STAFF REPORT
COMMUNITY DEVELOPMENT DEPARTMENT

HEARING DATE: 12/22/2020
 TO: Mayor & City Council
 FROM: Alan Tiefenbach
 208-489-0573
 SUBJECT: H-2020-0093
 Oakwind Estates Subdivision – PP and MDA
 LOCATION: Northeast Corner of N. McDermott Road and W. McMillan Road

Preliminary Plat (PP) proposal consisting of 94 single family lots, 92 townhouse lots, 3 common driveways and 26 common lots on 24.54 acres in the R-15 zone. A concurrent development agreement modification (Instrument #114030972) is submitted to change the development plan from multifamily and self-storage uses to the single family and townhome uses being proposed with the subject project. NOTE: The Oaks development agreement governs a larger area that what is being proposed with this development application. Therefore, the subject modification will exclude the subject property from the boundary of the overall DA, so the applicant can enter into a new DA with provisions that are relevant to the proposed development.

A. Preliminary Plat (date: ~~9/1/2020~~ 12/8/2020)

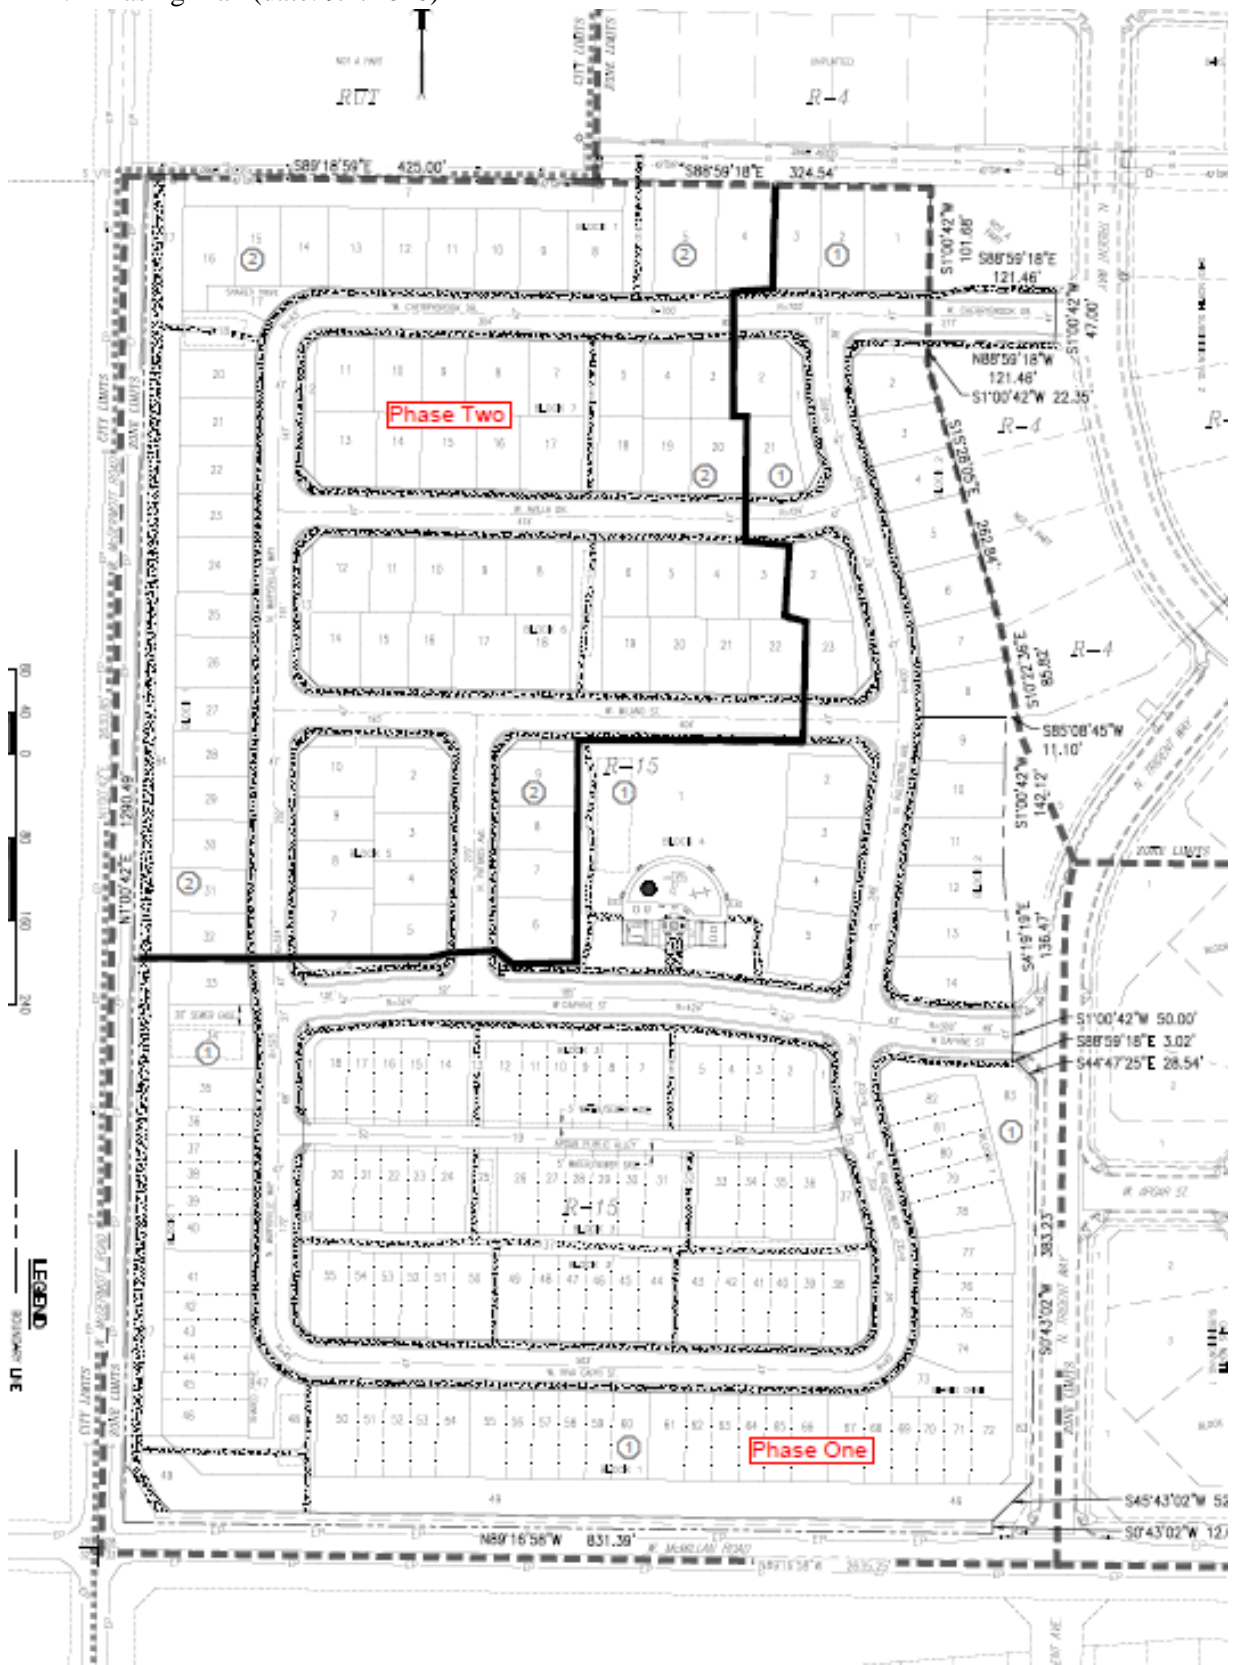
Per ACHD, Marysville Street and Palustris Avenue are proposed to be greater than 750-feet in length and will need to be redesigned to reduce the length of the roadways or to include the use of passive design elements. Stop signs, speed humps/bumps and valley gutter are not accepted as

2. The preliminary plat included in Section VII.A, shall be revised ten (10) days prior to the Council hearing as follows:
 - a. Note #10: Revise to include Lot 84, Block 1 as a common lot to be owned and maintained by the Home Owners Association.

- b. Marysville Street and Palustris Avenue will need to be redesigned to reduce the length of the roadways or to include the use of passive design elements. Stop signs, speed humps/bumps and valley gutter are not accepted as traffic calming. The applicant shall submit a revised preliminary plat showing the redesigned roadways and approved by ACHD prior to City Council.

traffic calming. Prior to City Council, the applicant should be required to submit a revised preliminary plat showing the redesigned roadways and approved by ACHD.

F. Townhouse Parking Plan

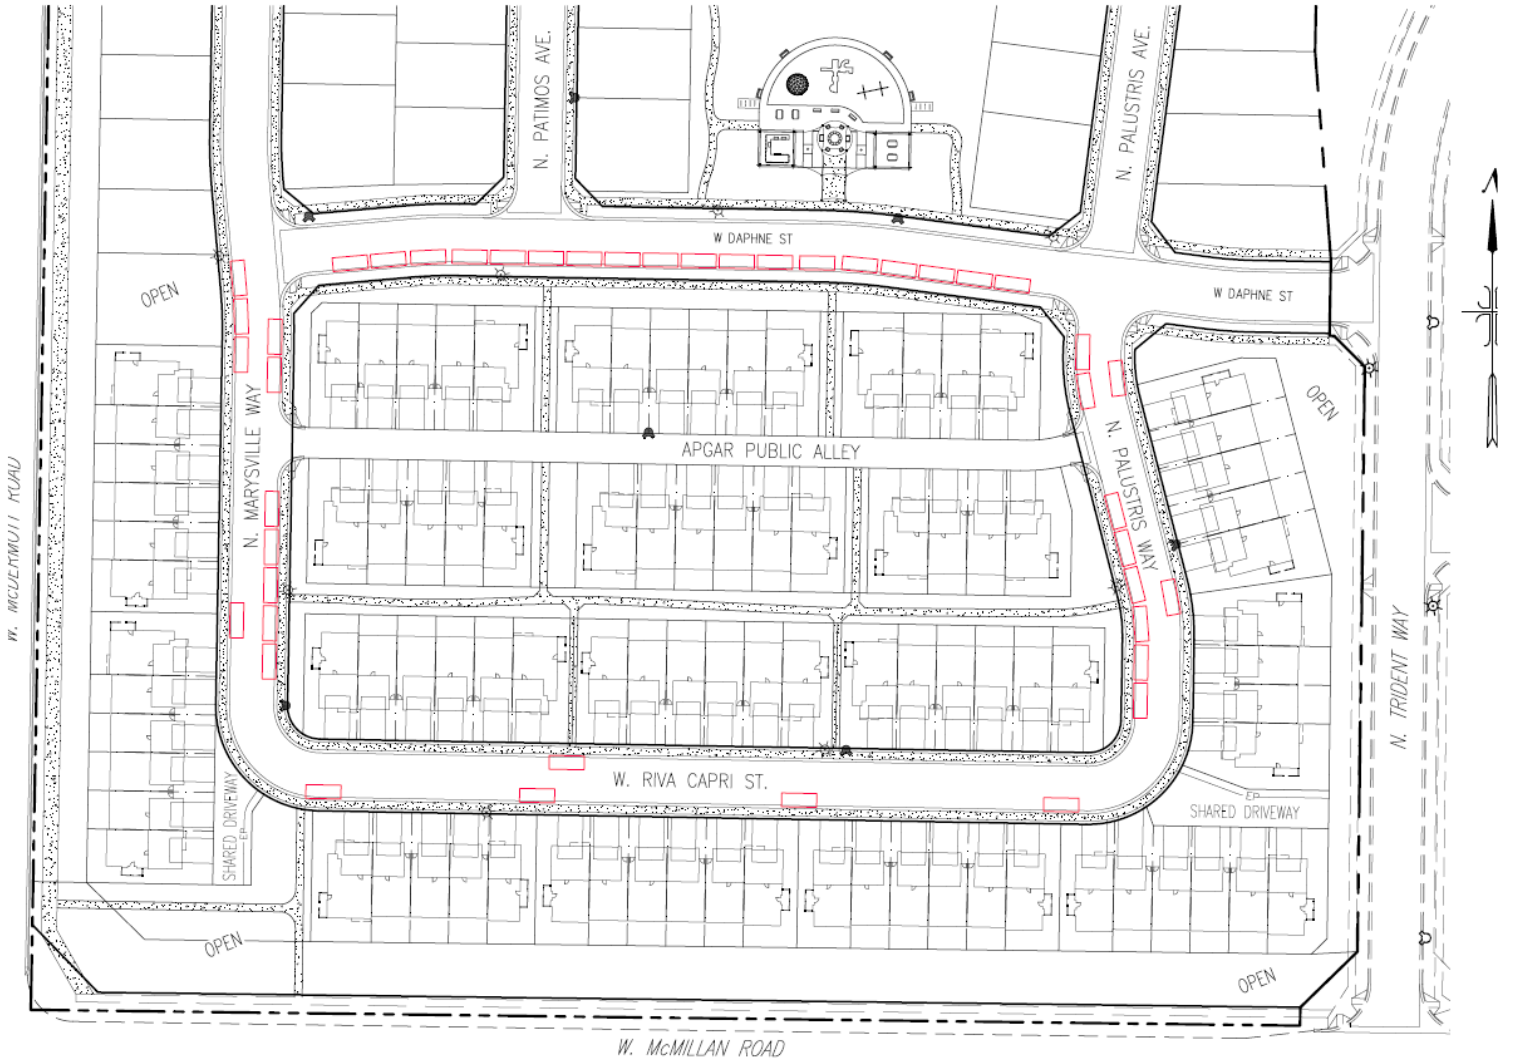
The applicant has provided a parking exhibit for the single family attached portion of the project (southern portion). The parking plan provides a 33' local street section which allows for additional on-street parking. It is important to note this on-street parking does not count toward meeting minimum requirements. ACHD and Meridian Fire have both reviewed the plan and have not expressed concerns.

- c. Expressed concerns regarding additional parking in the townhouse portion.
 - d. Preferred additional open space for the townhouse portion.
4. Commission change(s) to Staff recommendations (A new plat, amenity exhibit, landscape plan and elevations have been updated with the staff report to reflect the changes required by the Commission and ACHD. The applicant has not provided additional open space or parking):

- a. Recommended DA be modified to include a limitation to no more than 3 units on a common drive.
 - b. Recommended DA be modified to include revised conceptual plans that incorporate additional parking and open space for the townhouses.

- f. DA shall include a limitation to no more than 3 units on a common drive.
 - g. DA shall include revised conceptual plans that incorporate additional parking and open space for the townhouses.
